12 September 2023

RESPONSE TO OUTSTANDING MATTERS ADVICE FOR DEVELOPMENT APPLICATION AT 282 PARINGA RD MURARRIE QLD 4172 (COUNCIL REFERENCE: A006129295)

Figure 1 – Odour Modelling Results

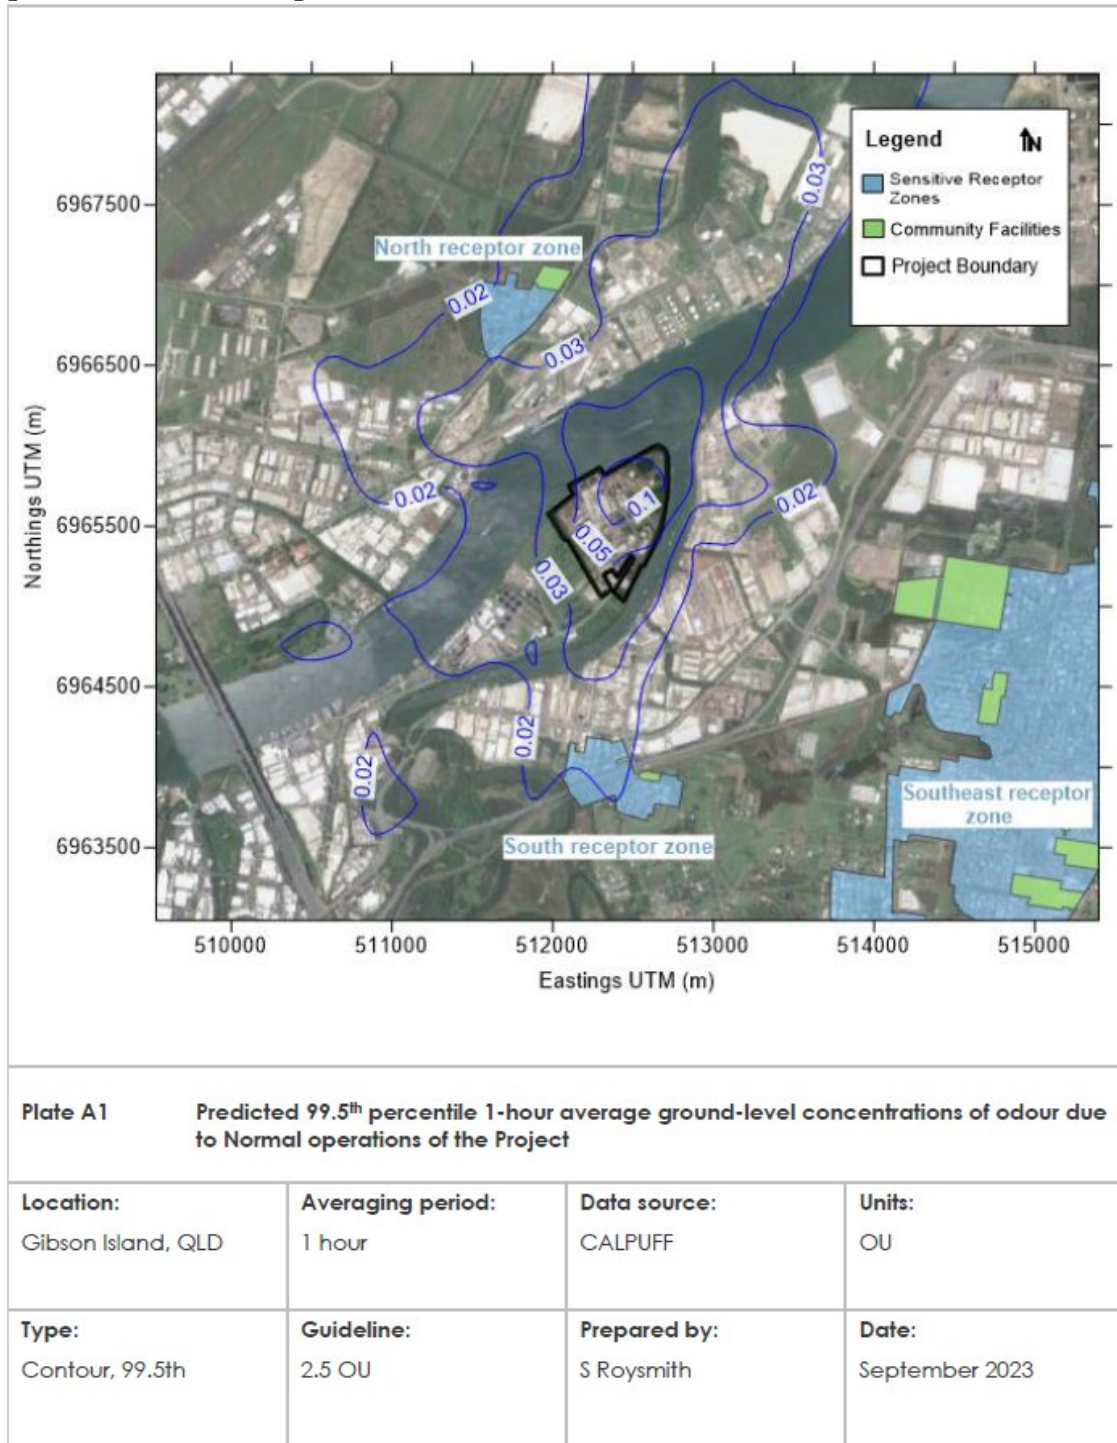
e. Include the assessment of odour (e.g. from ammonia).

Response:

The odour threshold for ammonia ranges from 5ppm to 53 ppm (3,794 µg/m³ to 40,223 µg/m³) in accordance with established research (<https://www.ncbi.nlm.nih.gov/books/NBK207883>).

Therefore, 1 OU = 3,794 µg/m³ has been utilised to determine predicted 1-hour, 99.5th percentile concentrations of odour for normal operations.

Tabulated results for the predicted 1-hour, 99.5th percentile concentrations of odour are presented in the table below and a contour is presented in **Figure 1** below. These results are well below the criteria permissible under Table 9.3.12.3.C.
